FINAL DRAINAGE REPORT

MERIDIAN ROAD & BENT GRASS MEADOWS DRIVE

El Paso County, Colorado

DATE:
November 2019

FUTURE MERIDIAN CHANNEL - PROFILE
SCALE: 1"=50' HORIZONTAL, 1"=5' VERTICAL

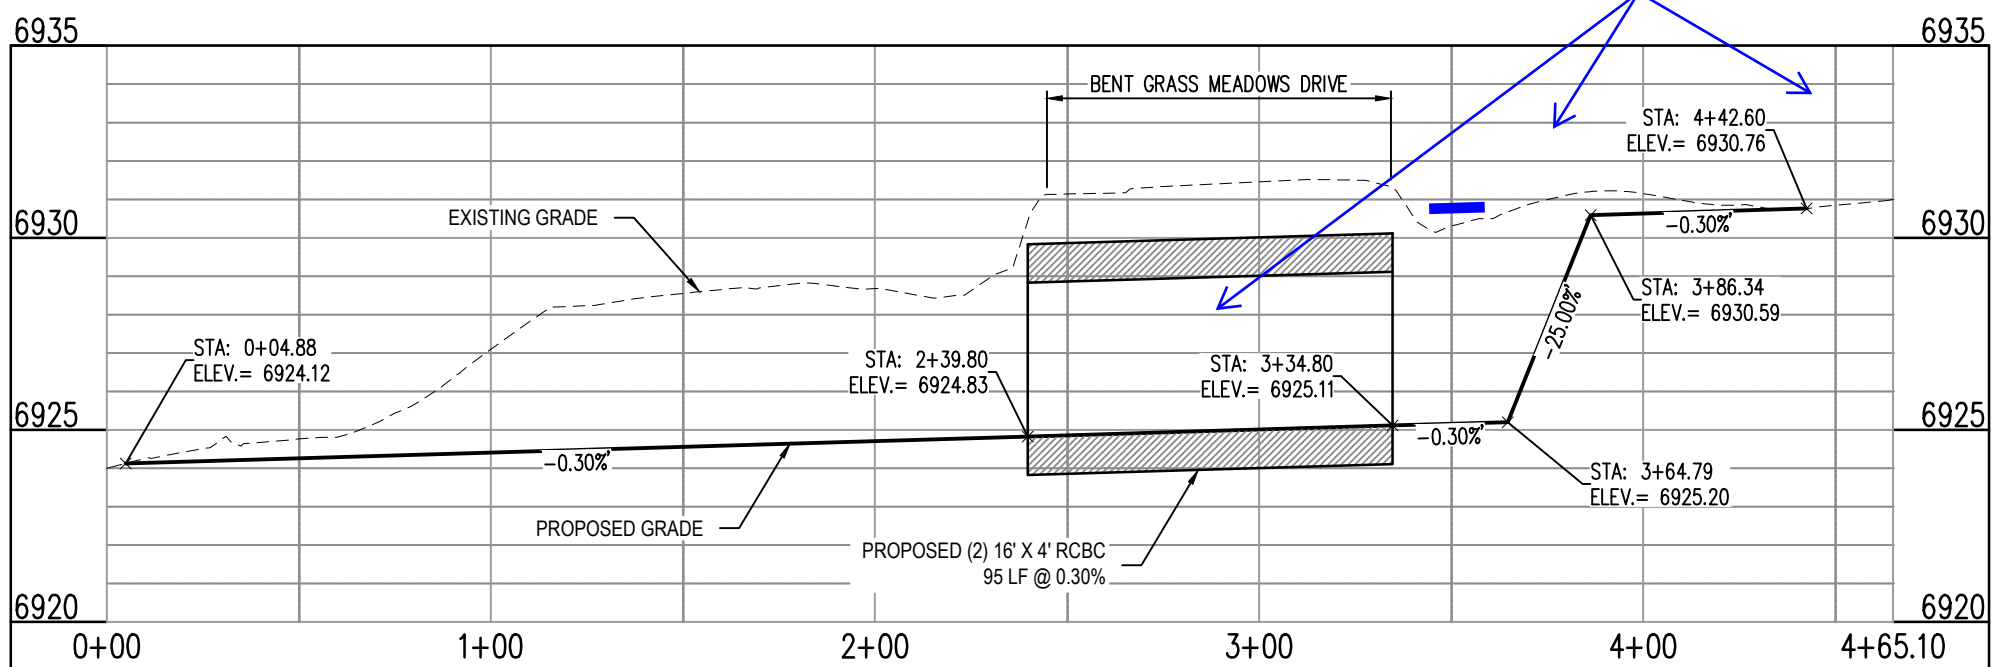
show HGL/headwater elev.
